SB Number:	SB 2HN-001	Creation Date: 18/02/2009
Subject:	<b>Black toner contamination at the main charger</b>	
Model:	<b>FS-C5100DN/5200DN/5300DN</b>

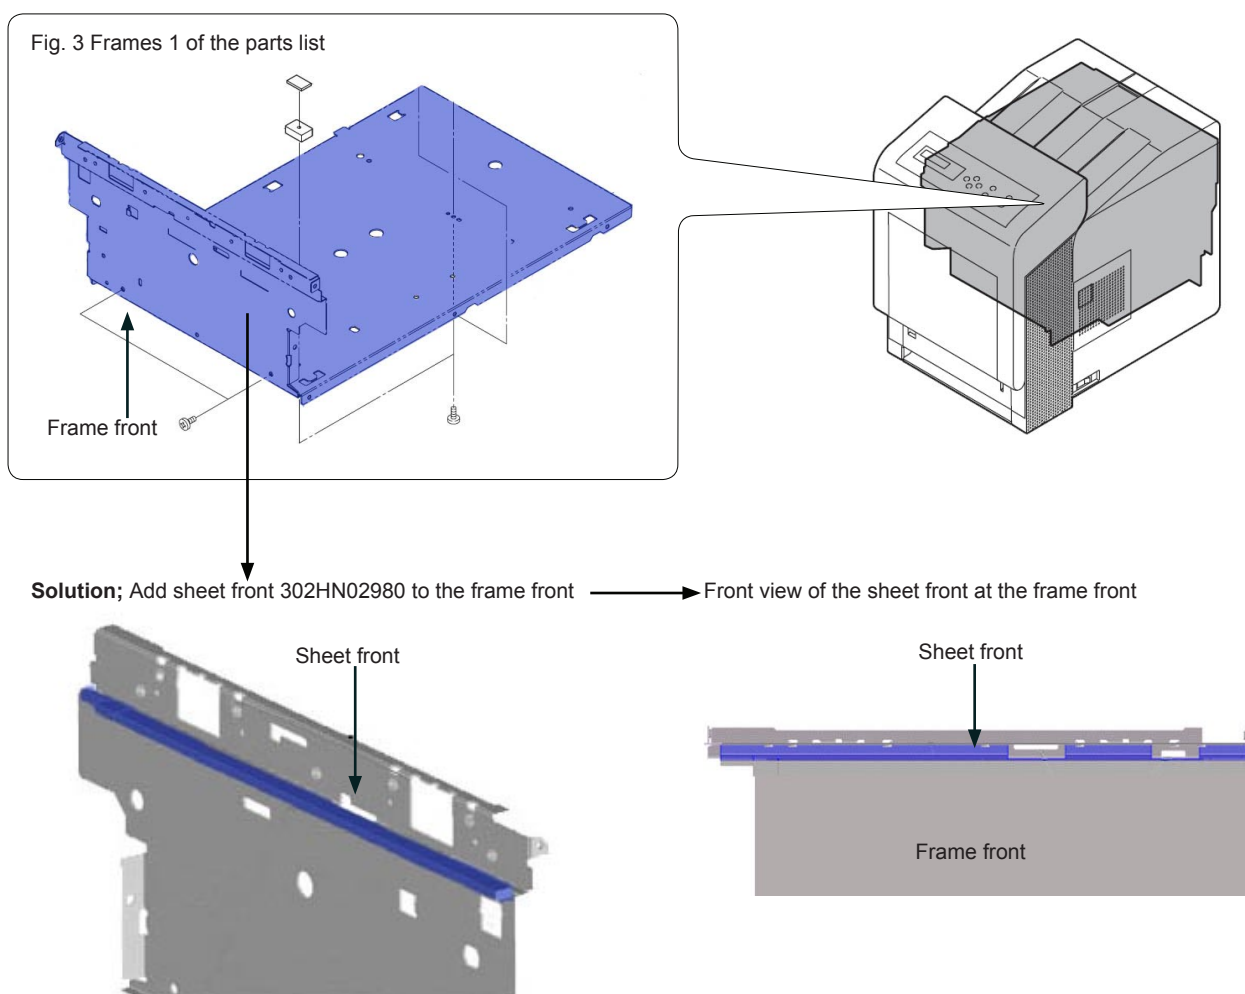
<b>Phenomenon</b>	The non-printable area of the main charger may become contaminated with black toner.
-------------------	--

<b>Solution</b>	Add sheet front 302HN02980 at the frame front.
-----------------	--
